I have reviewed documents associated with the Renewal of the Source Material License (No. SUA-1534) for Crow Butte, Nebraska and have found the applicant has not provided sufficient data to demonstrate proper development of (1) baseline water quality in the aquifer exemption zone and (2) excursion limits at monitoring wells.

United States Nuclear Regulatory Commission Official Hearing Exhibit In the Matter of: CROW BUTTE RESOURCES, INC. (License Renewal for the In Situ Leach Facility, Crawford, Nebraska)	
ASLBP #: 08-867-02-OLA-BD01 Docket #: 04008943 Exhibit #: INT-002-00-BD01 Admitted: 8/18/2015 Rejected: Other:	Identified: 8/18/2015 Withdrawn: Stricken:

Figure 1. Chart of aquifer exempt zone (i.e., zone surrounded by monitoring wells) and locations for baseline wells established with valid statistical methods.

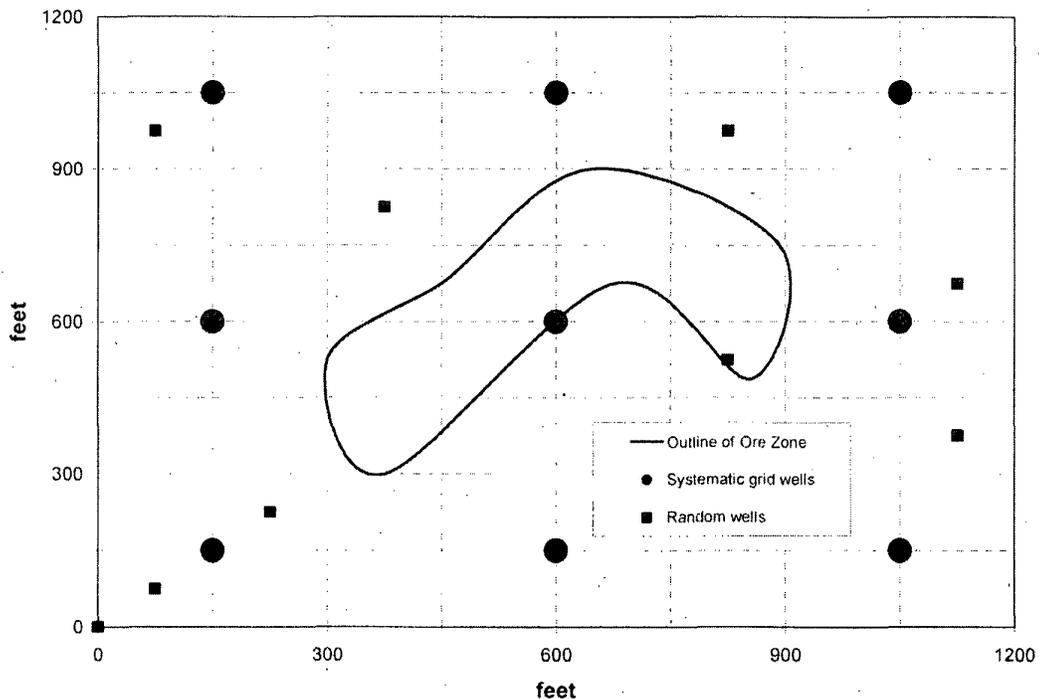
Figure 2.9-2 illustrates the proposed aquifer exemption zone around the ore bodies, and there is no statistical justification for the location of the baseline wells to validate that the results in Table 2.9-4 represent the water quality in the exempt zone. Note that the baseline wells in Figure 2.9-2 are clustered and not spread out over the entire exempt zone, and this violates statistical protocol. Within the aquifer exemption zone (i.e., the zone within the monitoring well ring), a systematic grid must be laid out to determine the location of the baseline water-quality wells. The density of nodes within the grid will be determined by the size of the area and the data quality objectives. Data quality objectives (EPA 2000a & 2000b) state the statistical confidence one wishes to have in the estimate of the mean (normal or log normal distribution) or median (no defined distribution) for the water-quality parameters. If a high level of confidence is required for an estimate of the mean or median, more baseline wells will be required.

Alternatively, we may elect to locate wells on the grid using a random number generator. In general, less wells are required if they are located randomly, and this is shown on Figure 1 as two random locations per quadrant. Free modeling software, developed by the Pacific Northwest National Laboratory for the Department of Energy (PNNL 2007), allows a large number of scenarios to be evaluated to determine the optimum data quality objectives and sampling approach for the stakeholders.

Figure 2. Cross section of an aquifer (20 to 90 feet) showing improper (Well 1) and proper (Well 2) sampling intervals to obtain a representative sample.

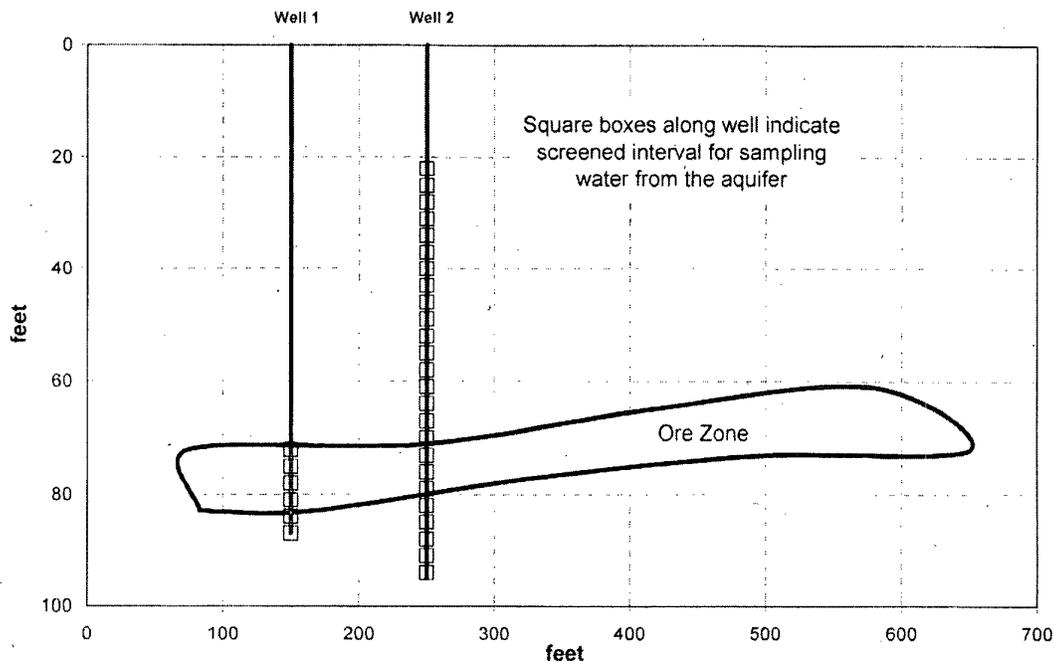
The well logs provided indicate the Chadron is approximately 50 to 80 feet thick through most of the mining area (Figures 2.6-4 through 2.6-11). The sampling interval for the baseline wells is 20 feet (Table 2.9-3), which does not represent the entire thickness of the aquifer. Figure 2 shows that a water sample obtained from Well 1, screened only in the ore zone, returns a biased sample that does not represent the water quality of the column of water at the given location. Well 2 (Figure 2) indicates the correct method for sampling the water, which requires that the entire thickness of the aquifer be screened to obtain a representative sample.

Figure 3. Probability plot indicating that all data do not lie near or on a straight line, which rules out a normal or log normal distribution.

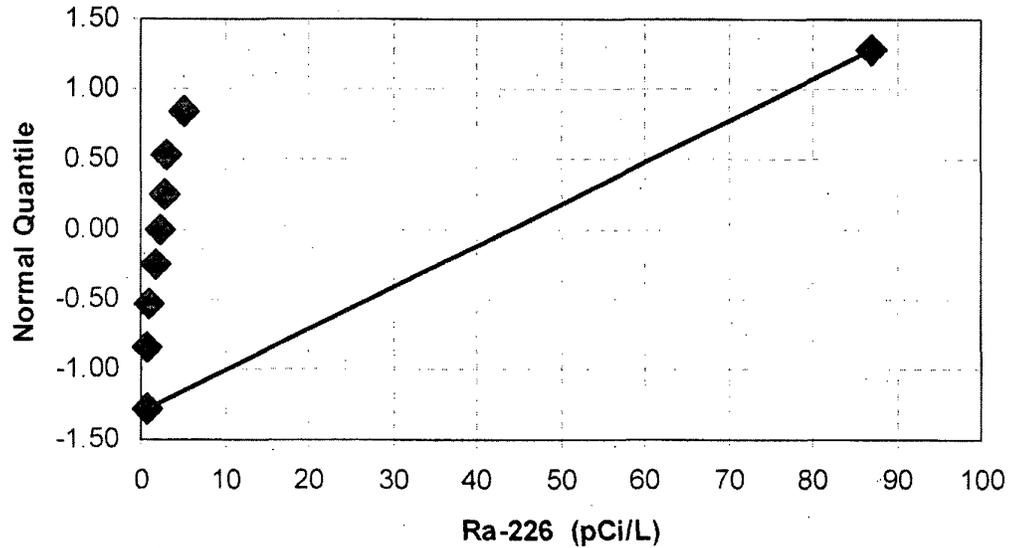
A probability plot of the data (Figure 3) and the results of the Shapiro-Wilk test confirm this. The normal-quantile values must fall on a straight line or the Shapiro-Wilk probability values must exceed 0.05 (at the 95 percent confidence level) for a normal or log normal distribution to be declared, which is clearly not the case. Therefore, the median, and not the mean, must be used to represent the central tendency of the data. Note that inappropriate use of the mean results in a high bias on the estimate of the baseline value for radium-226, which improperly elevates restoration clean-up levels and lowers the costs associated with the number of pore volumes needed to exchange to meet the clean-up levels.

Figure 4. Proper use of a control chart to determine lixiviant excursions.

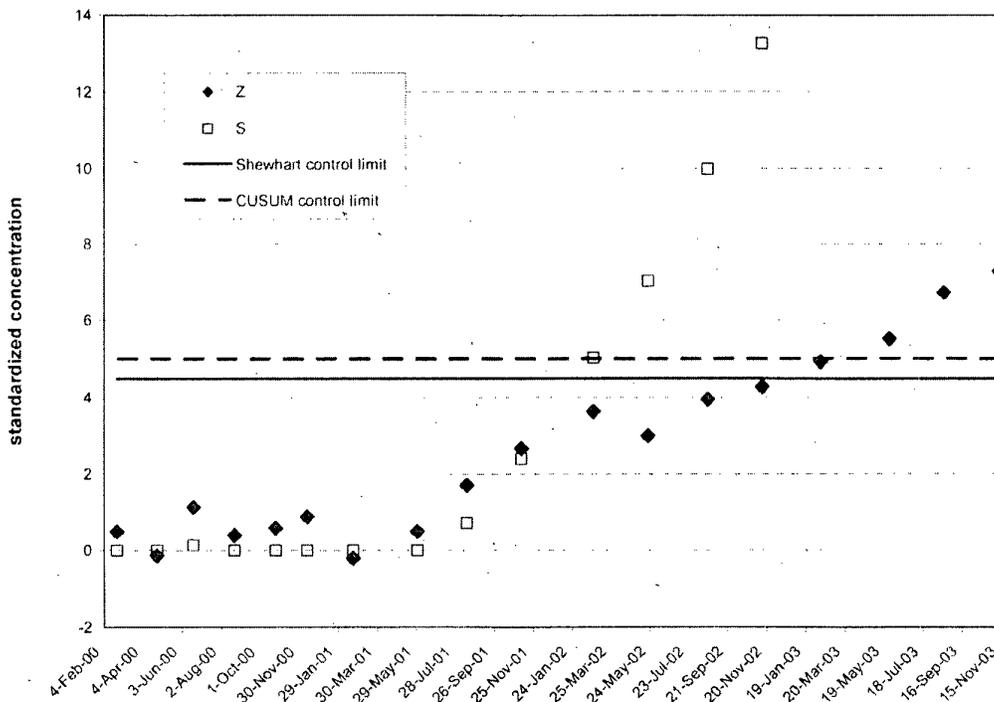
Figure 4 illustrates the importance of using the SCL and CUSUM for monitoring lixiviant excursion. The SCL (Z) and CUSUM (C) are plotted for an excursion parameter, a gradual increase in contamination exceeds the CUSUM limit in February of 2002, while the SCL limit is not exceeded until January of 2003. The SCL limit is similar to the CBR's use of 5 standard deviations above the mean for any one sampling event, although EPA recommends 4.5 standard deviations for any one sampling event. Using only the SCL limit allows contamination to migrate beyond the monitoring well for nearly a year before an excursion is declared. Therefore, if the CUSUM is not used with the SCL limit a gradual increase in contamination will not be detected and migration of diluted lixiviant will pass the monitoring well without corrective action.
